TO: Dr. Jesse Bacon, Superintendent
FROM: Danny Clemens, Director of Facilities
Date: February 9, 2024
RE: Bernheim Middle School - Change Order 6 - Art Room Sink **DC**

Change Order

PROJECT: *(Name and address)*
Bernheim Middle School Renovation
700 Audubon Drive, Shepherdsville, KY
40165

REQUEST FOR PROPOSAL

RFP-8

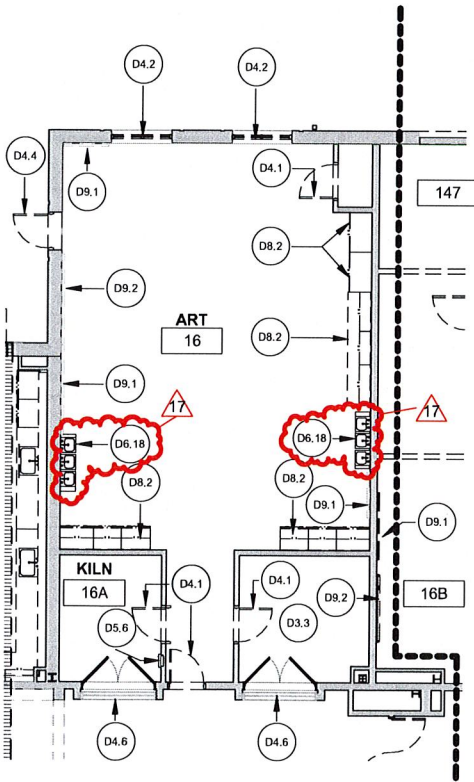
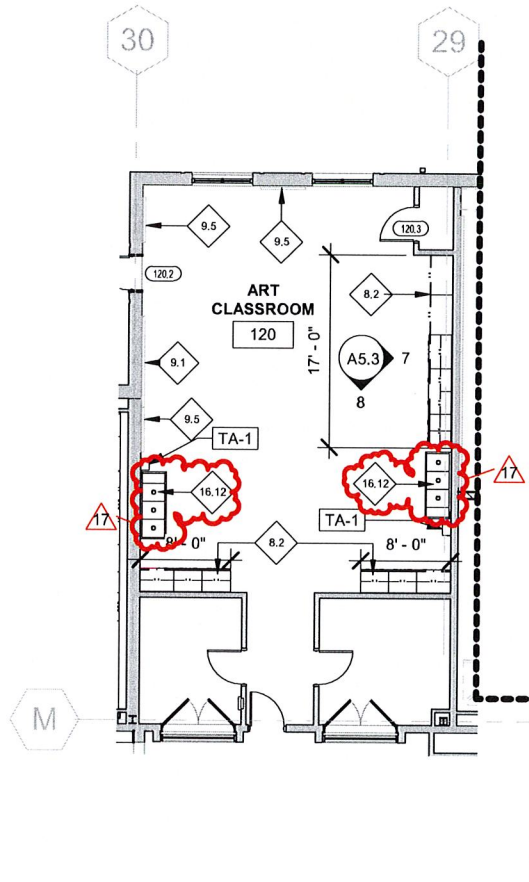
Remove existing sink basins in Art Room 120. Replace with a new three compartment sink and plaster trap.

16.12	NEW THREE COMPARTMENT SINK AND PLASTER TRAP, REF. PLUMBING DRAWINGS
D3.3	REMOVE AND DISPOSE OF GYP. BOARD CEILING ASSEMBLY, COMPLETE.
D4.1	REMOVE AND DISPOSE OF EXISTING DOOR AND HARDWARE. DOOR FRAME TO REMAIN, PREP FOR NEW DOOR INSTALLATION. IF HOLD OPENS ARE REMOVED, REPAIR VOIDS IN WALLS TO MATCH ADJACENT CONSTRUCTION.
D4.2	REMOVE AND DISPOSE OF EXISTING WINDOW ASSEMBLY, COMPLETE. PREPARE OPENING FOR NEW WINDOW INSTALLATION.
D4.4	REMOVE AND DISPOSE OF EXISTING DOOR, HARDWARE, AND FRAME, COMPLETE.
D4.6	EXISTING WINDOW ASSEMBLY TO REMAIN. PROTECT DURING CONSTRUCTION.
D5.6	REMOVE AND DISPOSE OF EXISTING FIRE EXTINGUISHER CABINET. SALVAGE FIRE EXTINGUISHER AND RETURN TO SCHOOL STAFF. MAINTAIN WALL RECESS AND PREP FOR INSTALLATION OF NEW CABINET.
D6.18	REMOVE AND DISPOSE OF EXISTING PLUMBING FIXTURE, COORDINATE WITH PLUMBING DRAWINGS
D8.2	REMOVE AND DISPOSE OF EXISTING CASEWORK, COMPLETE. COORDINATE CAPPING OF ANY UTILITIES WITH MEP DRAWINGS. PATCH AND PAINT WALL TO MATCH ADJACENT CONSTRUCTION.

SHEET
 P2.1A

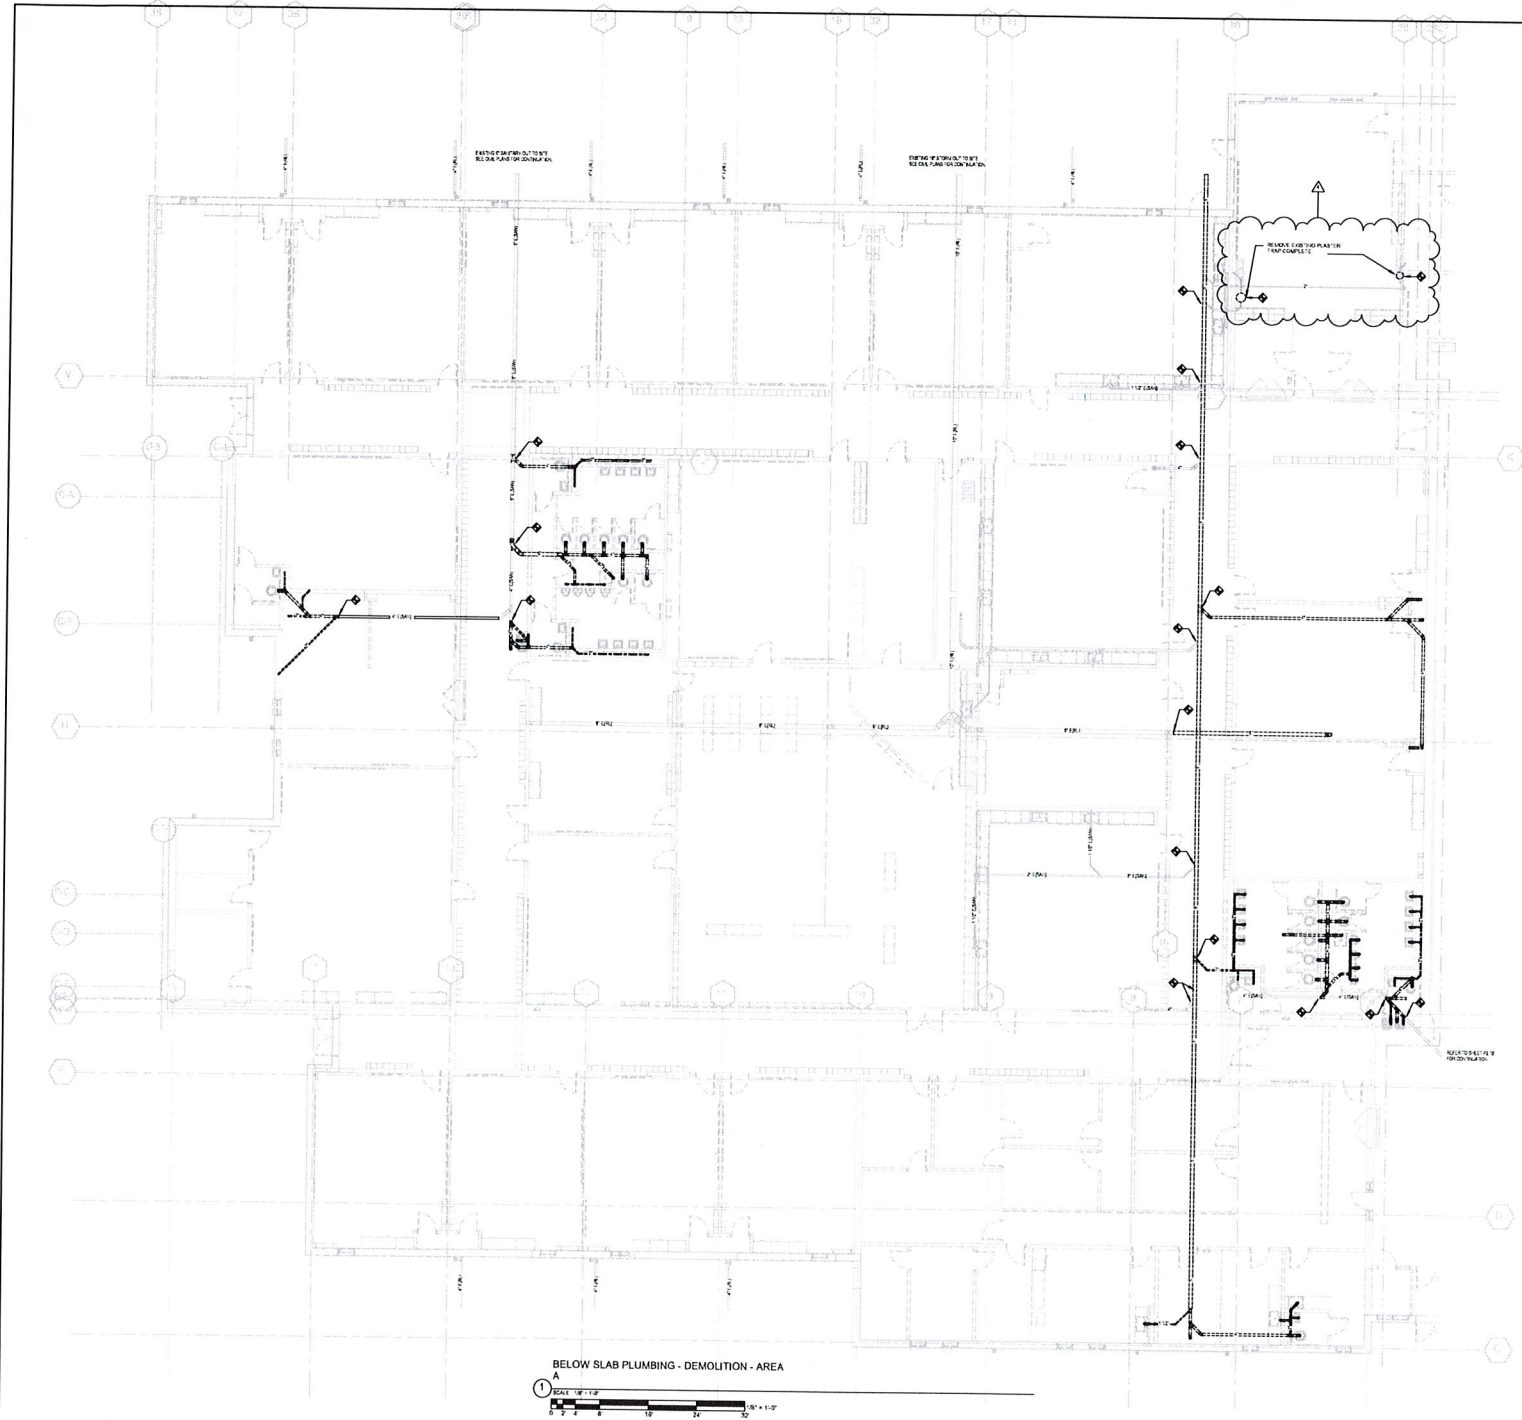
PDF: RFP-8, P2.1A, P3.1A, P3.2A
